TECHNICAL BULLETIN	
	October 2004 TB 2205
Mfg:	GM
Model:	C-SERIES
Liter:	6.0L
V I N:	U
Year:	99-06

Second Design Connecting Rod Bolt & Torque Specification
1997-1999 GM 4.8, 5.3, 5.7, 6.0L VIN G, U, T & V Engines

Bulletin Diagram: FIGURE 1. REVISED CONNECTING ROD BOLT - CYLINDER BLOCK

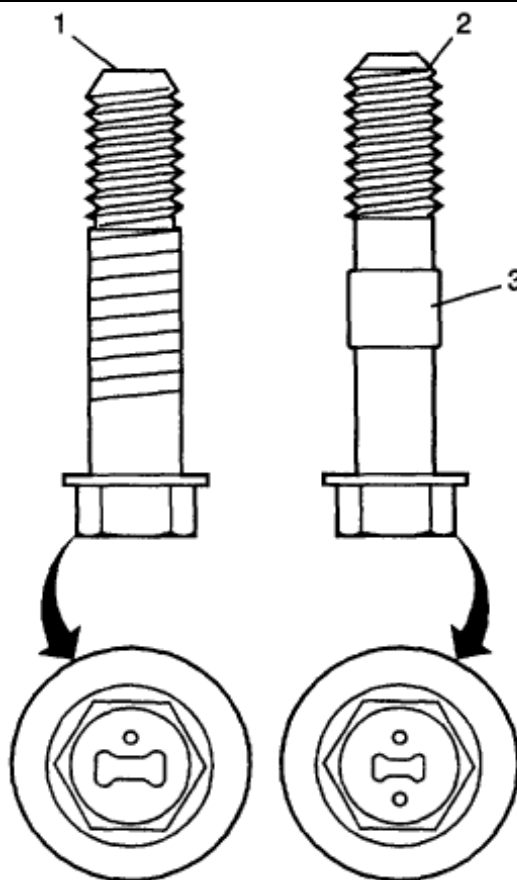
The first design connecting rod bolt (1) can be identified by a single dimple/mark on the head of the bolt and no retaining sleeve (3) on the bolt shank.

The second design connecting rod bolt (2) can be identified by two dimples/ marks on the head of the bolt and a retaining sleeve (3) on the bolt shank.

Important: When replacing the connecting rod bolts, both bolts MUST be of the same design for each connecting rod assembly. The use of different design connecting rod bolts on the same connecting rod may lead to uneven clamp loads and/ or connecting rod bearing bore distortion.

Tighten the first design bolt: 1ST pass to 15 FT/LBS, final pass turn + 60°.

Tighten the second design bolt: 1ST pass to 15 FT/LBS, final pass turn + 85°.
